Gas Reclaim BPR water Stagnation

The present technical bulletin contains technical information aimed to support/improve Drass equipment currently in operation.

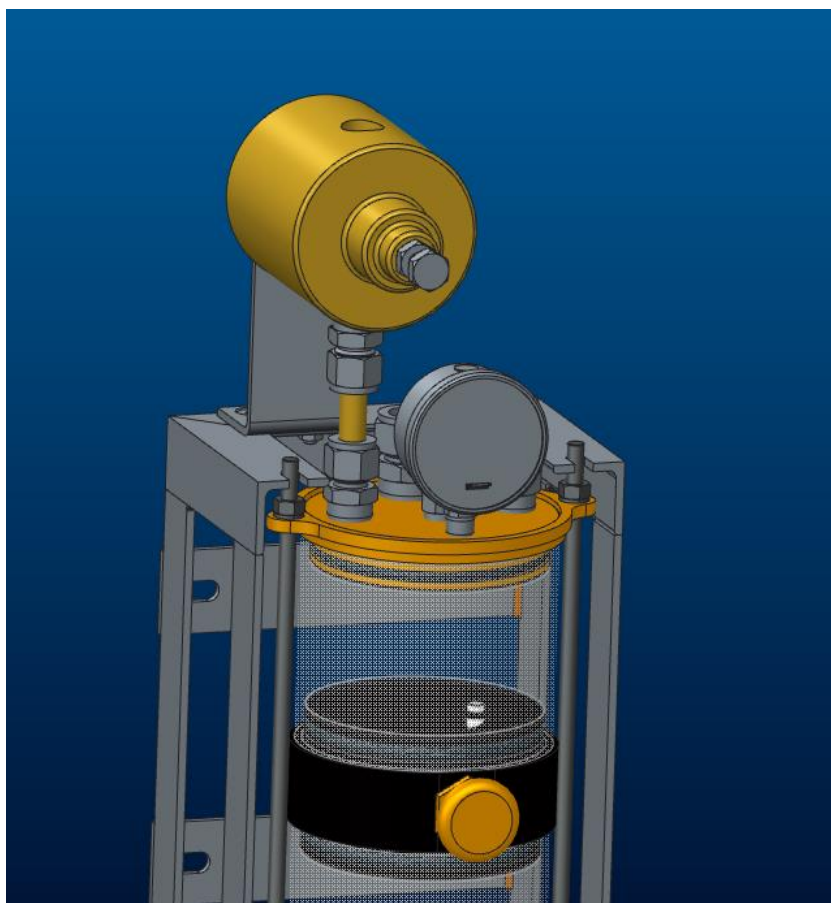
Stagnation of water inside the BPR of the Water Trap. This could happen because the BPR is installed in vertical position. The water stagnation area is highlighted in green in the below image.

The solution of this issue is to change the orientation of the BPR. The back pressure regulator shall be installed vertically on the water trap to allow the drainage of the water from the BPR to the water trap.
